Product Change Notice (PCN)

PCN Number: PCN-0450586R-01

Product(s) Affected: PJ-010A, PJ-010B, PJ-010AH, PJ-010BH

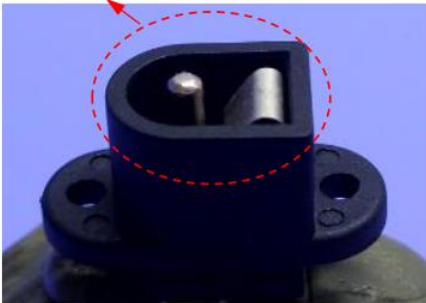
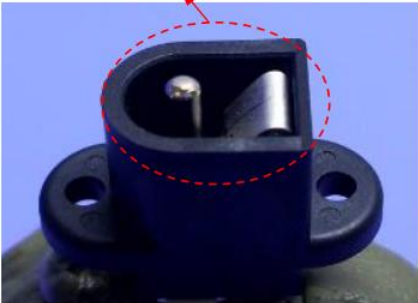
Current version	New version
Outlook		
Front	 <p>without chamfer</p>	 <p>with chamfer</p>

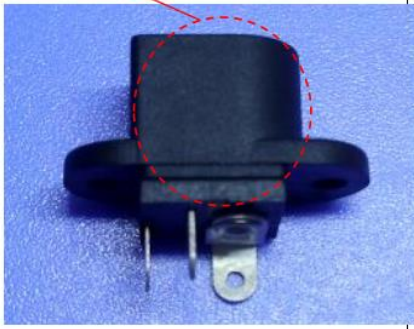
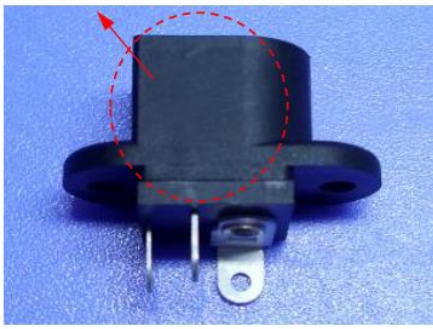
<p>Back</p>	<p>cave marking location</p>  <p>cave marking location</p>	<p>cave marking location cave marking location</p> 
<p>Top</p>	<p>rough surface</p> 	<p>smooth surface</p> 
<p>Bottom</p>	<p>rough surface without injection</p>  <p>thickness of pin#2 is 0.2mm</p>	<p>smooth surface with injection mark</p>  <p>thickness of pin#2 is 0.25mm</p>

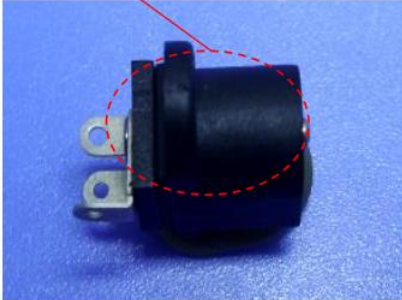
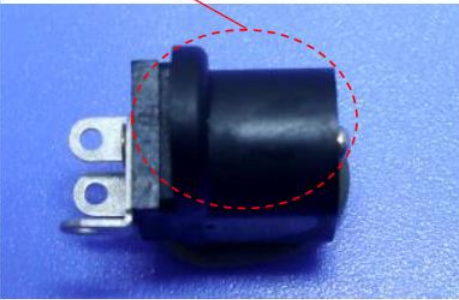
Description of Change: Thickness of pin 2 changed from 0.2mm to 0.25mm. Aesthetic changes as shown in below comparisons:

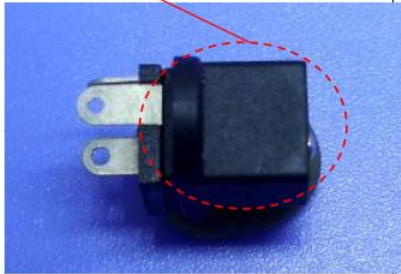
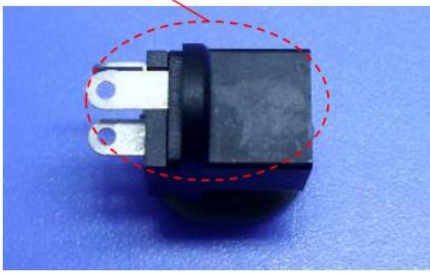
Right	<p>rough surface</p> 	<p>smooth surface</p> 
Left	<p>rough surface</p> 	<p>smooth surface</p>
